**AGENDA
ARCHITECTURAL COMMISSION
REGULAR MEETING**

Monday, July 18, 2022 at 7:00 P.M.

**Location: Long Grove Village Hall
3110 Old McHenry Road, Long Grove, IL 60047**

Reference: Architectural Modification Request Approval Letter
7237 RFD Greywall Court, Long Grove, IL 60060
XN1523199 Acct# 51976912

LEFT ELEVATION

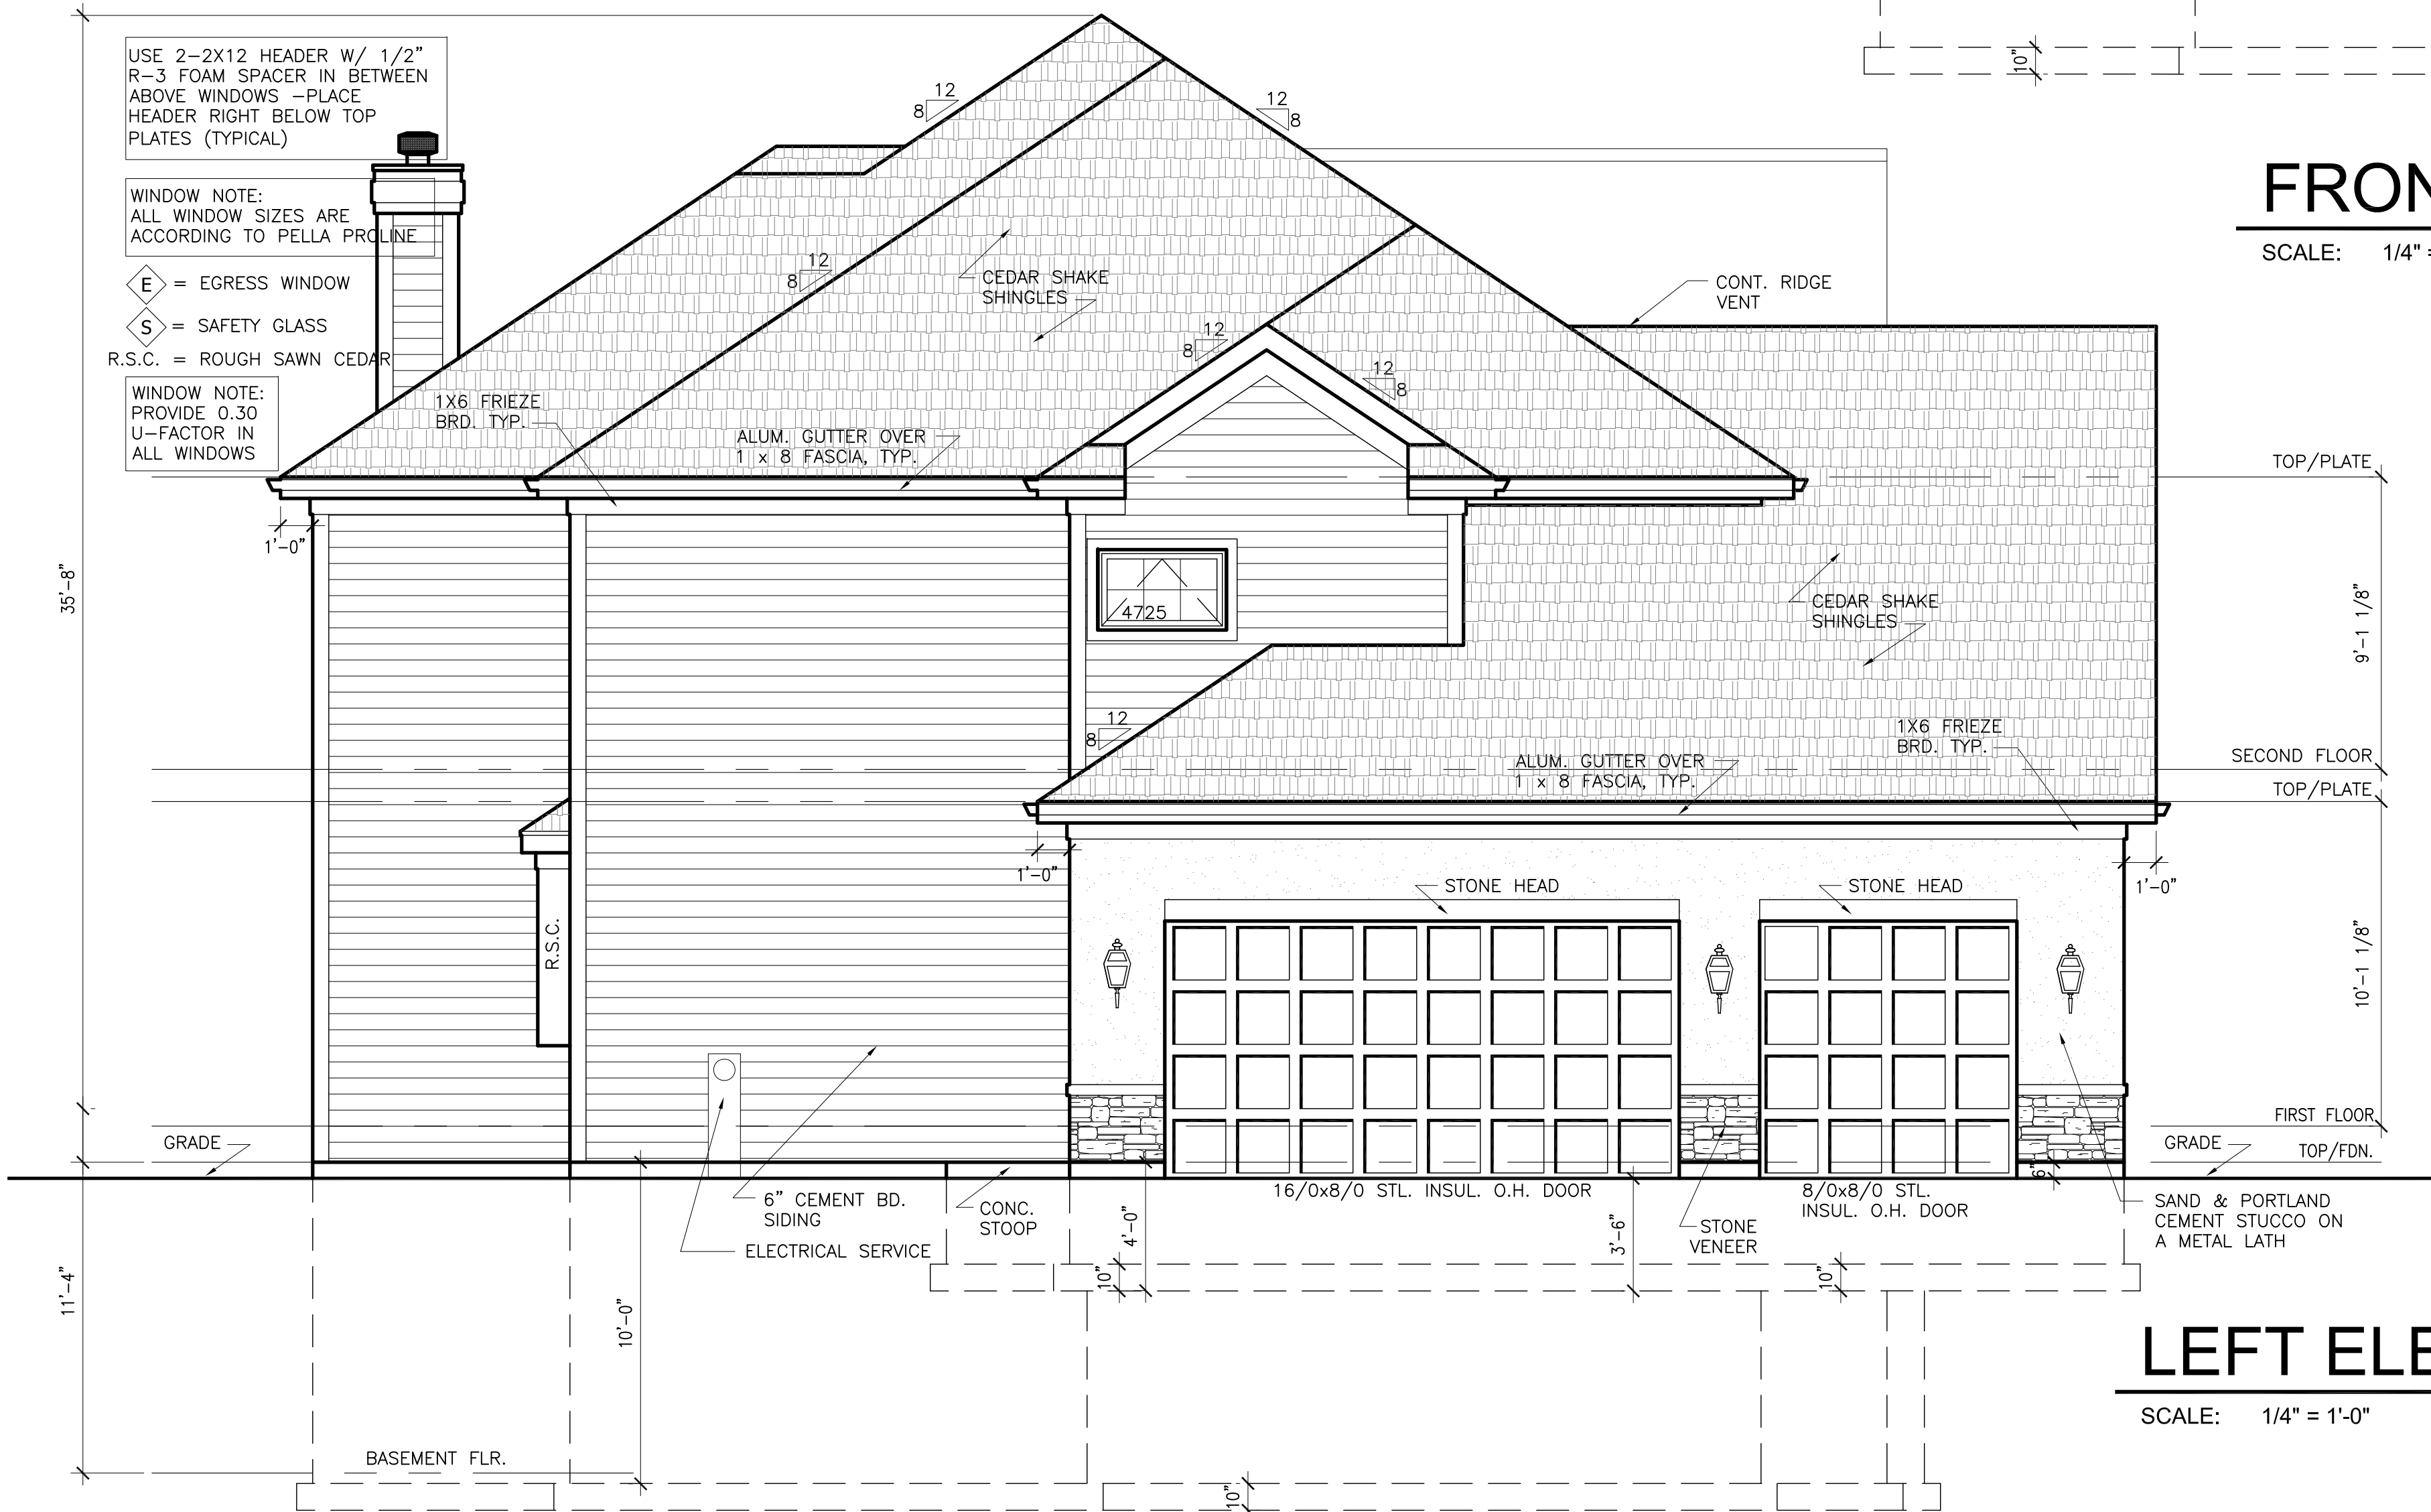
1- We will do cedar shake shingles per plan attached. 2- Stone will be provided just as it shows on then drawings 3- The chimney was added to the Drawings, please see attached drawings 4-Please see attached stone picture. 5- The material colors were provided on the initial submission of documents. 6-We are working on the plan, but if you can approve the permit we will provide later. 7- The Rear elevation was updated with the sliding on the living room.
